Response to Submissions

Boollwarroo Parade, Shell Cove
Section 75W Modification Application

Submitted to Department of Planning and
Environment
On behalf of Frasers Property Australia

31 May 2018 | 16075

Figure 1 Precinct E - Indicative Section

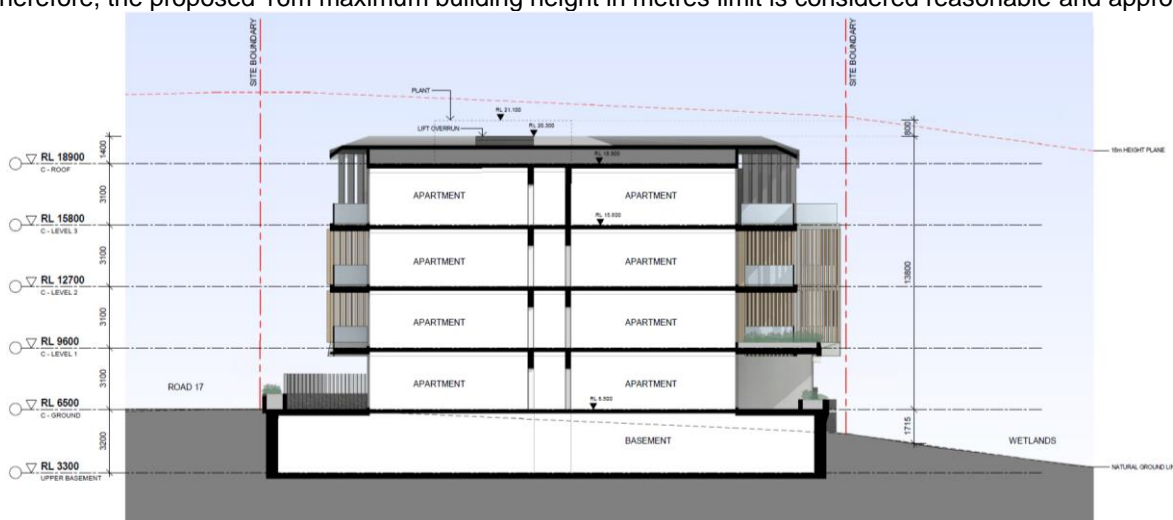
“there is scope to reduce the maximum building heights across the site while still achieving the same number of proposed storeys. Consideration should, therefore, be given to reducing the maximum heights particularly for:

- *the four storey/16m apartments in Precincts E, F and G*
- *the two storey + attic/11m houses in Precincts A, B1, C1 G and H*
- *the three storey/12m townhouses in Precinct E, F, G, H*
- *clarification regarding the potential community use in Precinct D requiring the two storey/15m height and mixed-use land use in Precinct D with the two storey/12 height.”*

Frasers have reviewed the 16m building height limit and wish to maintain the 16m maximum height limit for the proposed four storey apartment buildings in Precincts E, F and G. The rationale for this is outlined in the table and discussion below.

The application of the building height rationale is illustrated in the reference section provided as **Figure 1** below. The section is provided for reference only and does not form part of the modification application. The drawing illustrates a section of the proposed four storey apartment building in Precinct E, and demonstrates how the future four storey building relates to the 16m maximum building height in metres. The reference design provides a 12.4m height from the finished floor level of the ground floor apartment to the underside of the ceiling of the top floor apartment. When the basement (half-in/half-out), roof structure and plant and slope on the site are accommodated the height of the building is close to 16m.

Therefore, the proposed 16m maximum building height in metres limit is considered reasonable and appropriate.

Figure 6 Rear setback diagram for lots adjacent to the dry boat storage

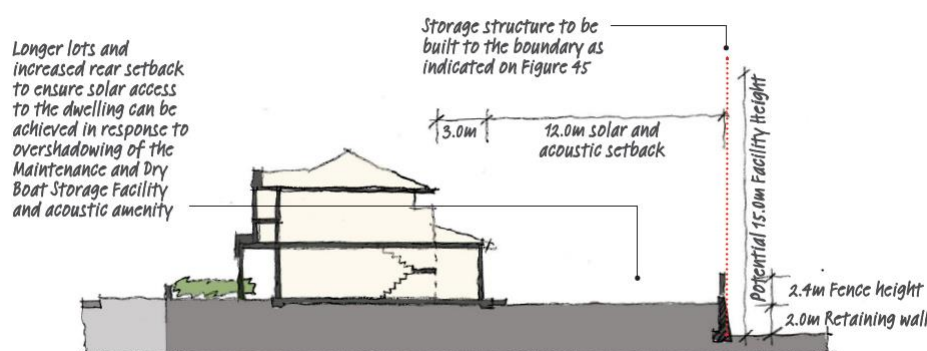
“Further consideration be given to the residential layout next to the boat storage lot. The current layout compromises the level of solar access to the adjoining properties during mid-winter as a result of overshadowing from the proposed acoustic wall. An alternative layout should be considered to minimise amenity impacts on future residential properties.”

Frasers have reviewed the proposed residential layout with regard to the Department’s comment, and wish to maintain the residential layout as proposed. The proposed layout is considered to be reasonable for the following reasons:

- The Precinct A Urban Design Guidelines for Detached Housing apply to the residential lots adjacent to the boat storage lot. The UDGs require:
 - Deeper lots adjoining the boat maintenance facility to minimise the impact of overshadowing throughout the year (refer to **Figure 6** below);
 - All detached housing lots to provide a minimum of 24m² principal private open space; with a requirement to provide direct solar access to 50% of the private open space for a minimum of 2 hours in mid-winter. The deep lots proposed next to the boat storage lot enable direct solar access to a minimum of 26m² of the private open space adjoining the dwelling for 2 hours in mid-winter, and to a minimum of 156m² of the private open space on December 22. This exceeds the minimum solar access requirements for a standard detached dwelling lot in Precinct A.

The residential lots adjacent to the boat storage lot have been designed to offset any unreasonable solar impacts of the acoustic wall along the northern boundary. The increased depth of the lots will result in the private open space receiving direct solar access to a greater square metre area than is required for a standard residential lot in Precinct A. Therefore, the level of solar access to the nine lots next to the boat storage lot is considered reasonable and will not have an adverse impact on the amenity of the future dwellings.
